STAFF REPORT AND RECOMMENDATION TO THE DESIGN COMMISSION - DENIAL

CASE FILE: LU 17-111569 DZM (PC # 16-284738)
1327 NW 19th
REVIEW BY: Design Commission
WHEN: February 15, 2018, 1:30pm
WHERE: 1900 SW Fourth Ave., Room 2500B
Portland, OR 97201

1 NORTH ELEVATION
SCALE: 1/8" = 1'-0"

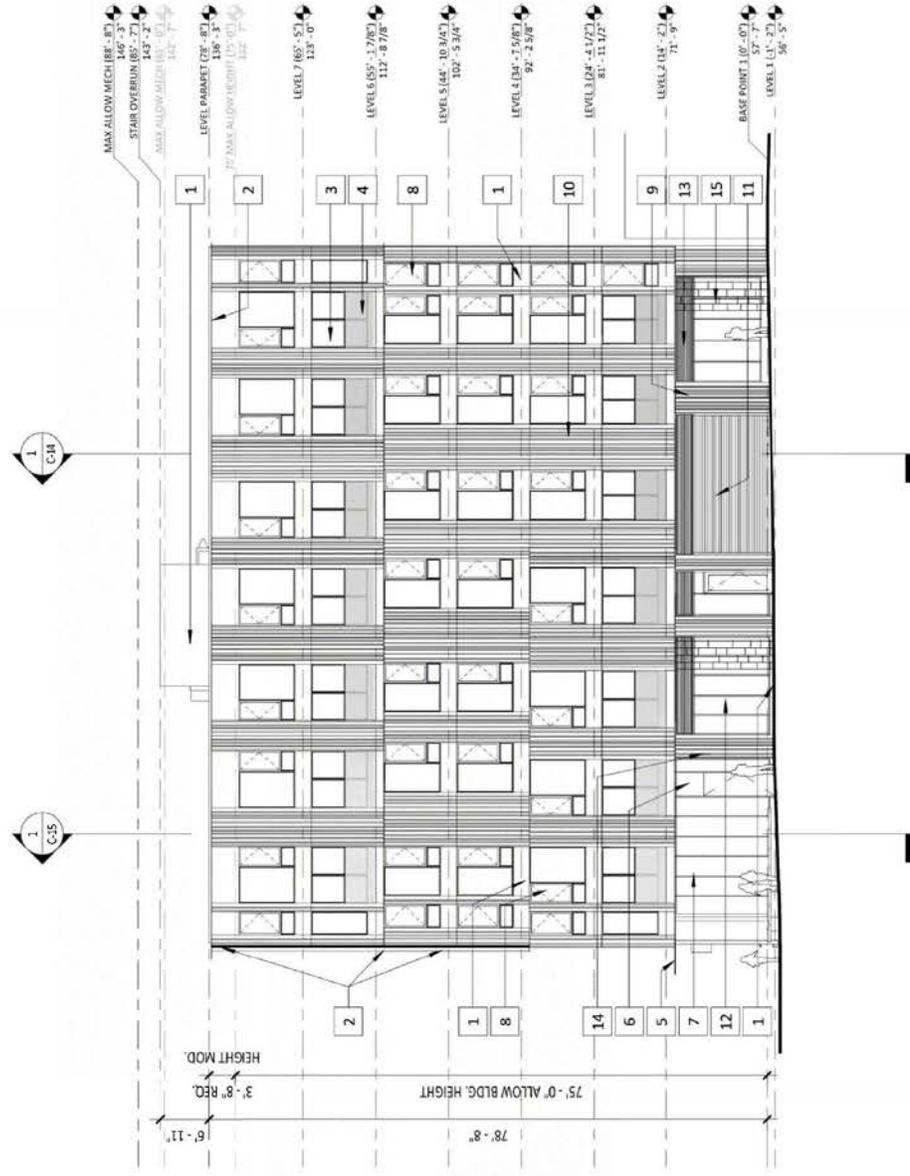
- a. D4. Parking Areas and Garages. Large storefront windows to the west of the garage door on NW Pettygrove Street open directly into the mechanized parking. ***Views into a parking structure are not considered an attractive or complementary resolution.***
- b. Ground Floor Windows (33.140.230.C). Proposal provides 40% rather than the required 50% minimum length required of qualifying windows. ***It has not yet been illustrated how this Modification merits approval.***
